RE: CHANGE TO APPLICATION AND APPLICANT RESPONSE TO INFORMATION REQUEST REFERENCED AS CA 2025_5880/1 (1363256)

Applicant Response to Information Request

We refer to the Information Request issued by Douglas Shire Council dated 5 May 2026 (Doc ID: 1363256) under Section 12 of the Development Assessment Rules in respect of the above-referenced development application. We thank Council Officers for their detailed review and constructive advice notes.

Updated Concept Landscaping Plan

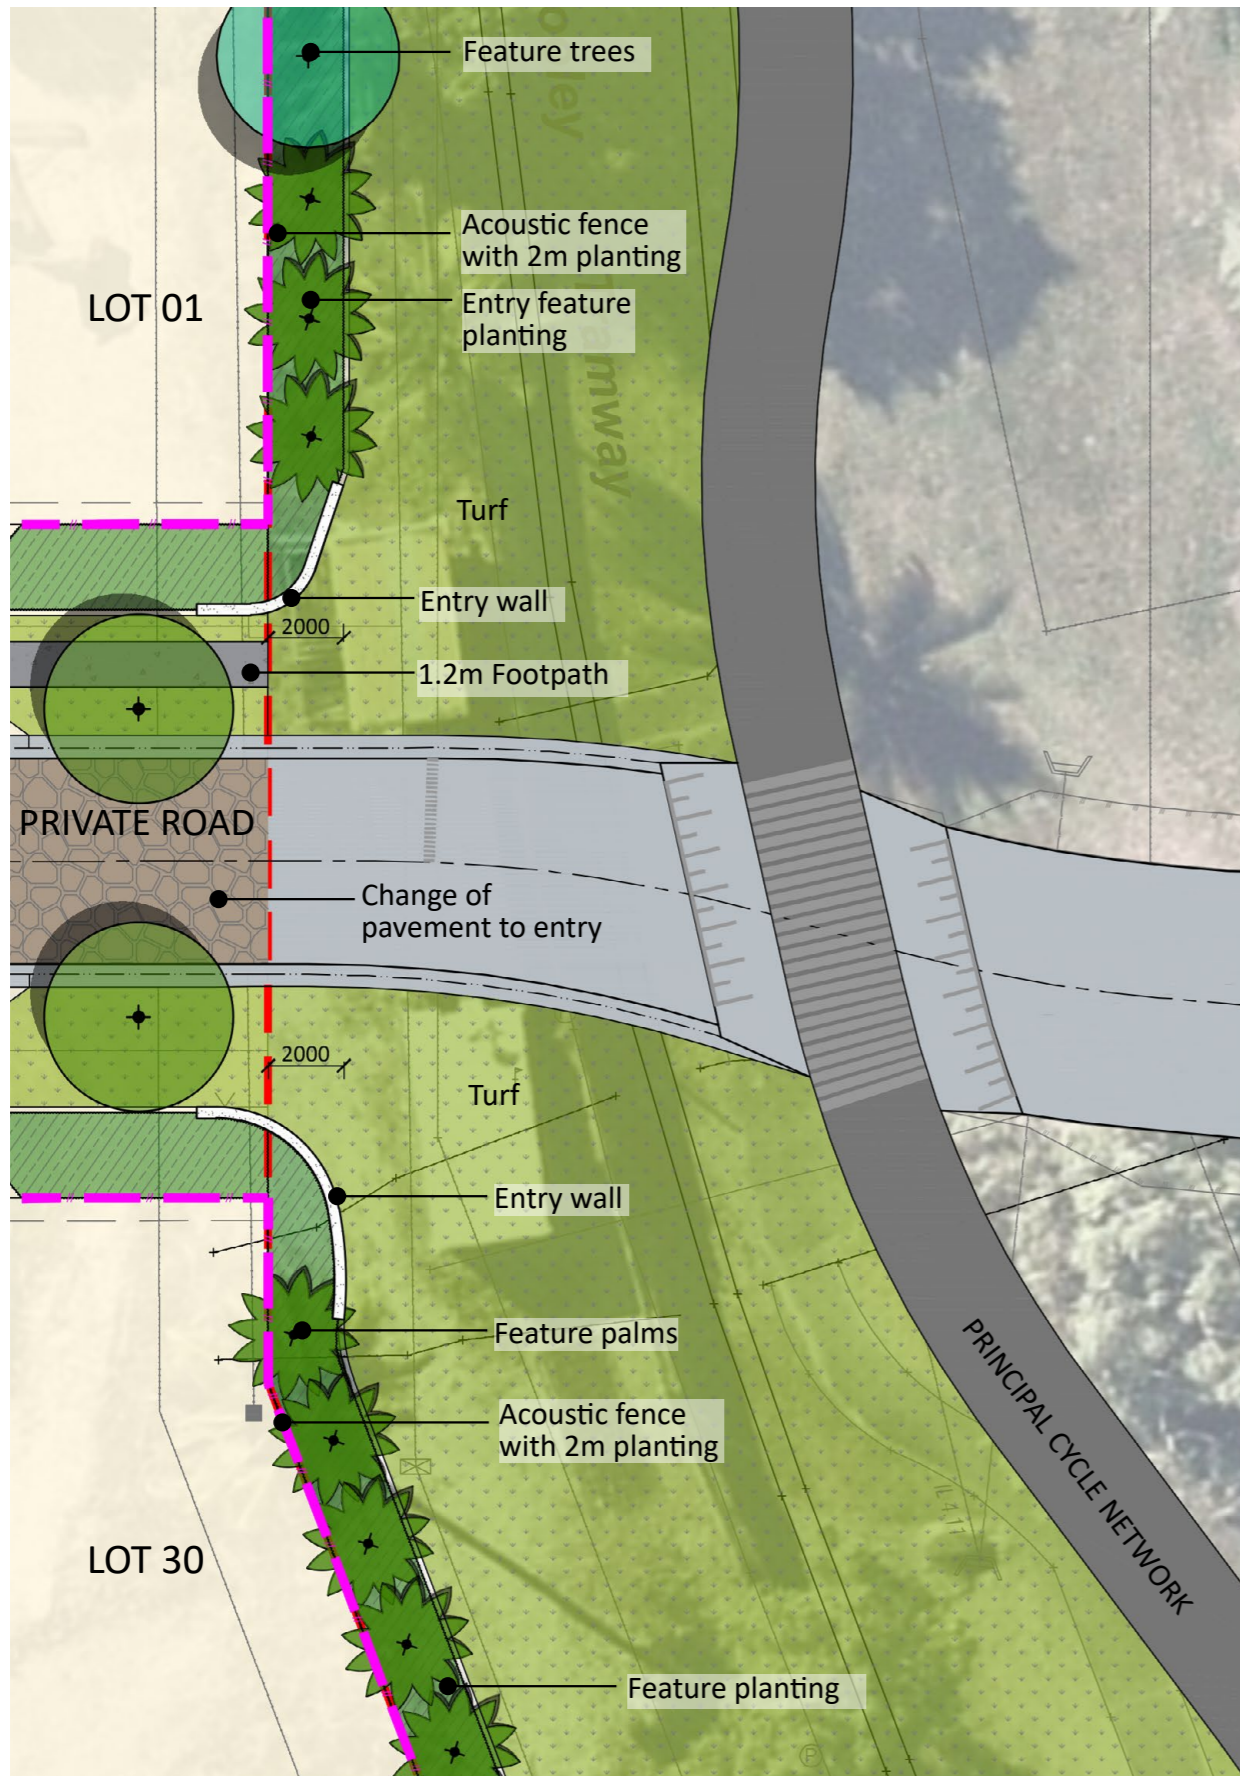
Item 27 – Updated Concept Landscaping Plan

An updated Concept Landscaping Plan has been prepared and is enclosed as **Attachment 6**. The updated plan addresses each of the matters raised by Council as follows:

- (a) A 2-metre-wide landscape planting area has been incorporated along the full frontage of the site fronting Port Douglas Road to visually screen and soften the acoustic fence. The landscape planting area has been designed to accommodate existing and proposed infrastructure (stormwater, footpath, electricity, telecommunications) and proposed driveways, with appropriate species selection and offsets from services.
- (b) Where services are located below ground, appropriate landscape species have been selected to avoid damage to underground infrastructure and will be addressed in full as part of the detailed landscape plan.
- (c) The reference to "New Road" has been removed from the drawings titled "Proposed Landscape Plan" and "Proposed Entry and Plant List". The road is now shown as "Private Road" to remove ambiguity.
